GJS Plot F, Manchester

Non-material Amendment | 23.08.2024

Z1-SHP-A180-RP-XX-NMA02 | P02

Updated Proposal - F2-SHP-G200-PL-Grd-B5D801 - P05

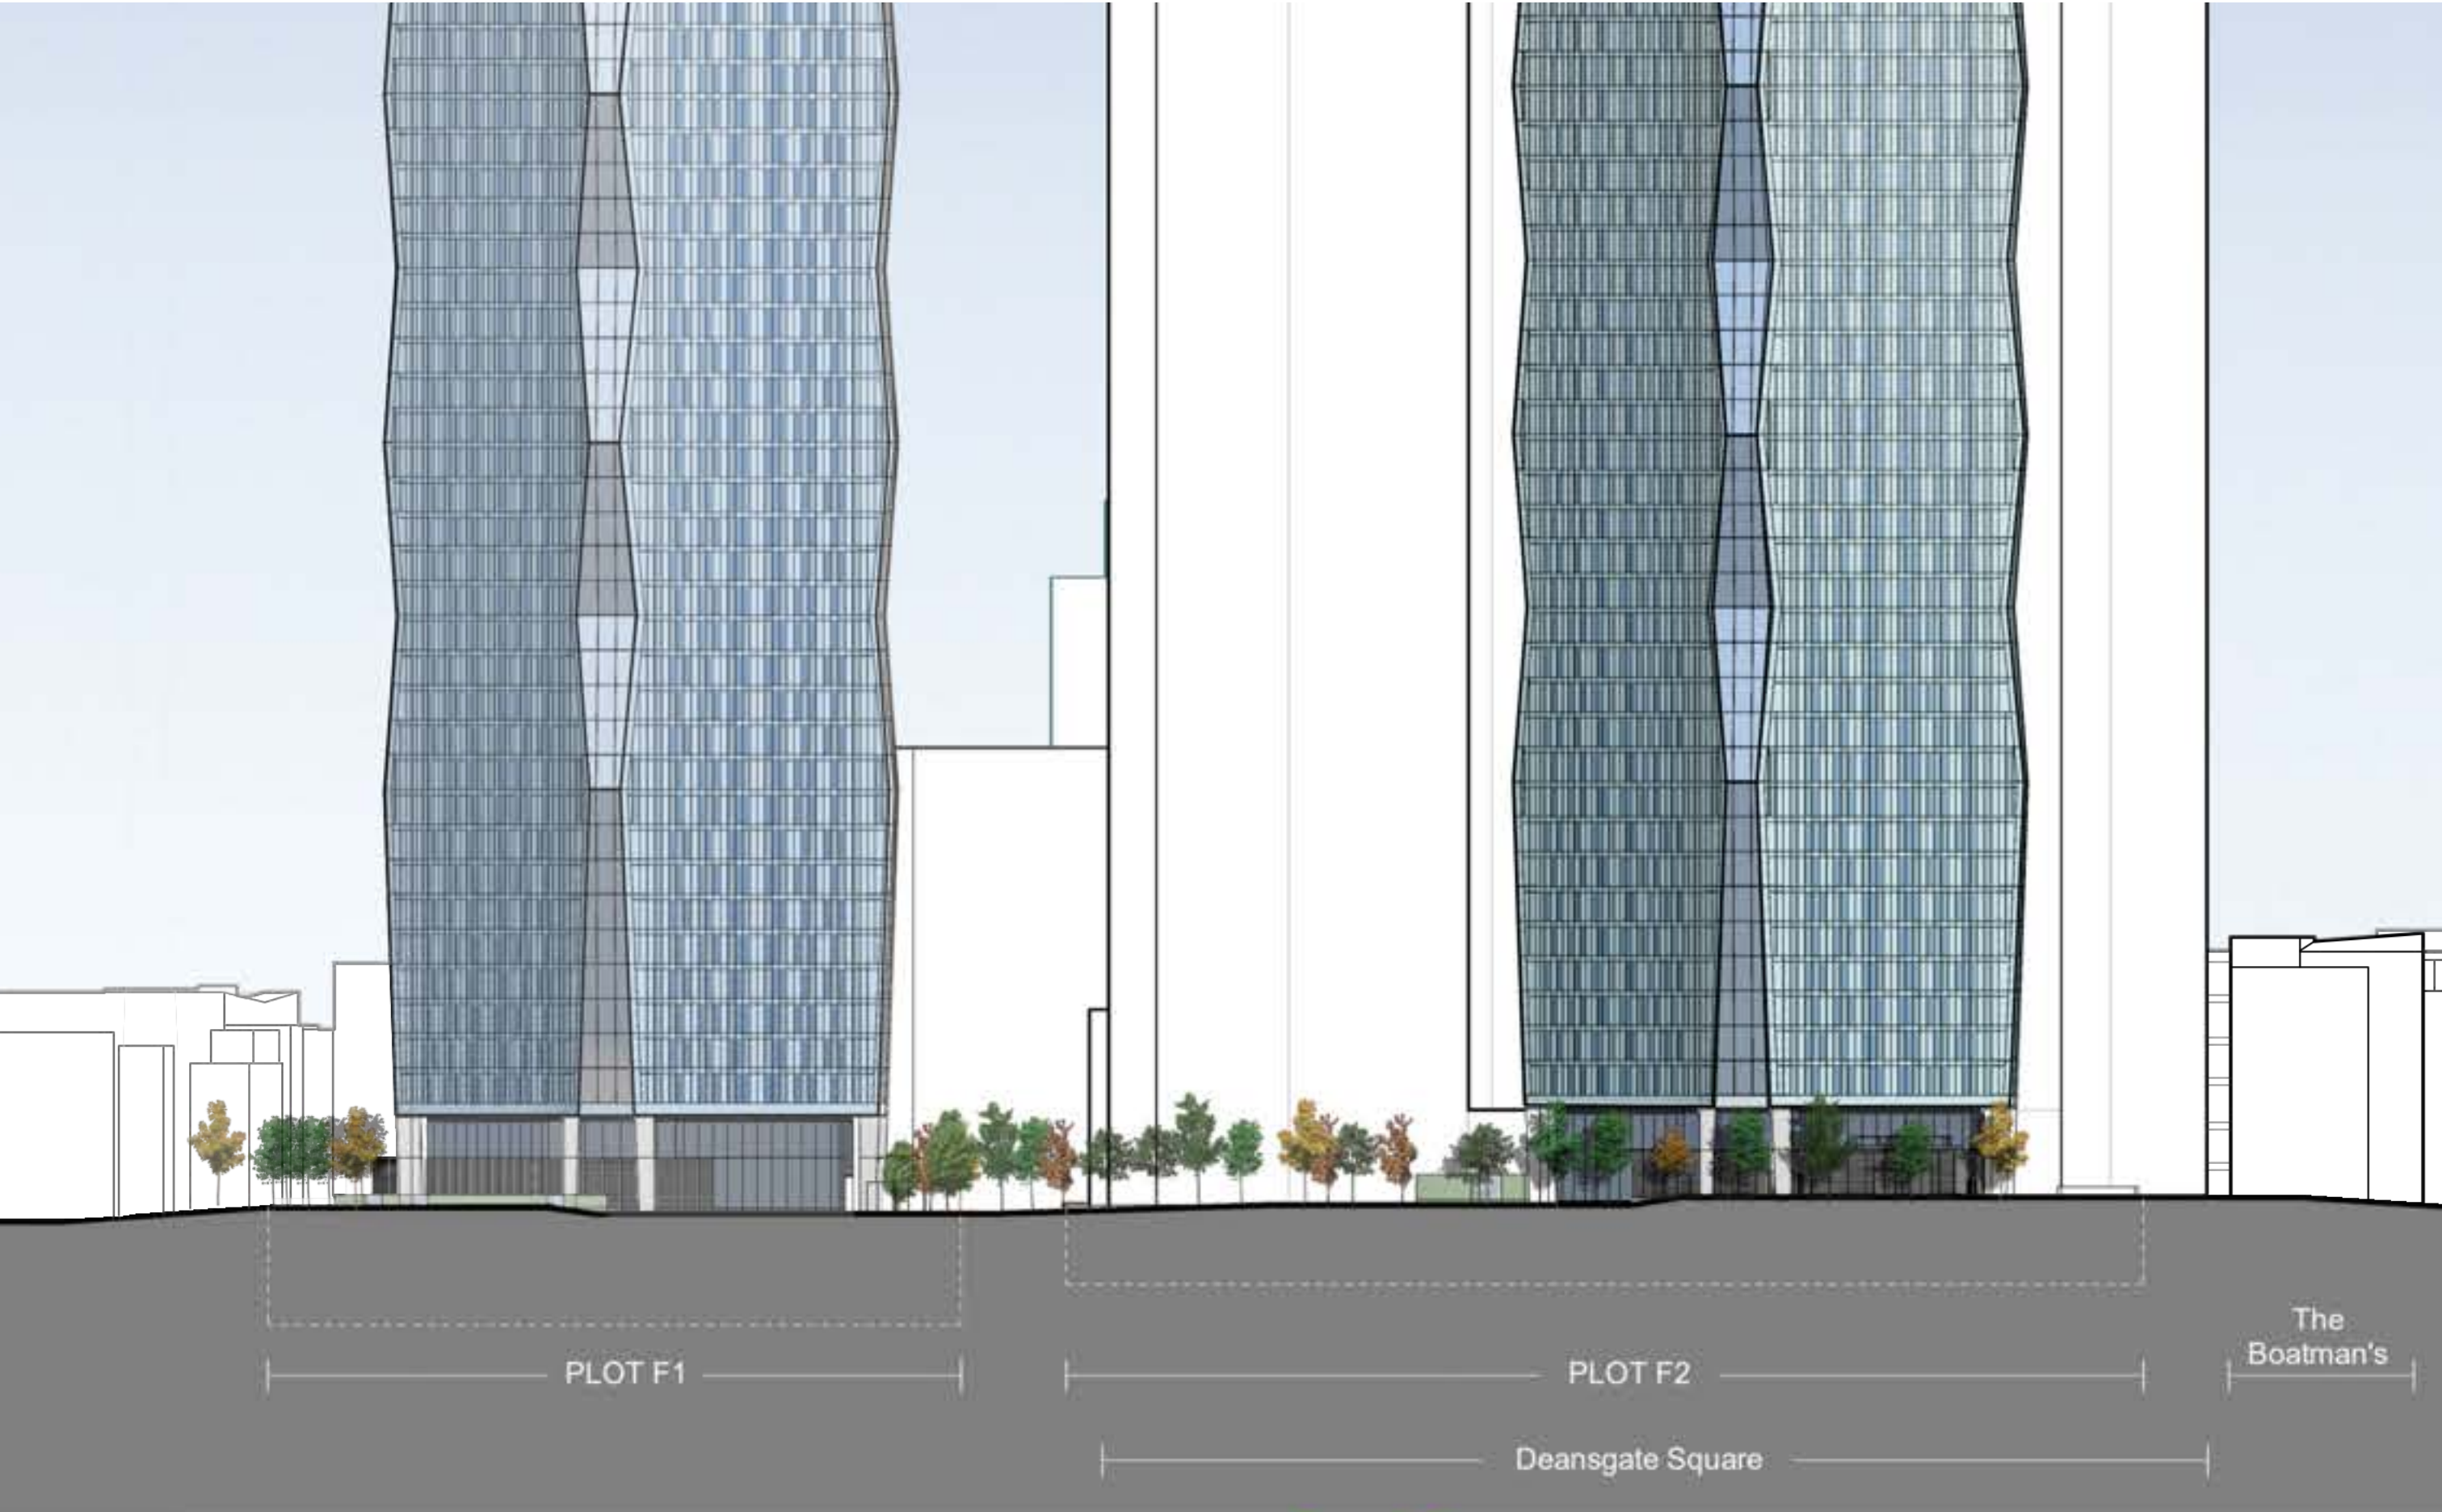
Tower F2 - Pond Street changes; raised boundary at the private garden and re configuration of the stair enclosure

The landscape boundary treatment to the pond street elevation of F2 has been reconfigured, allowing a greater landscaping zone and wider footpath.

Additionally the standalone escape stair that forms part of the F2 garden wall has been reduced in length but increased in width slightly to accommodate a smoke extract shaft to the stair lobbies. The overall footprint is similar to that of the consented scheme.
4.
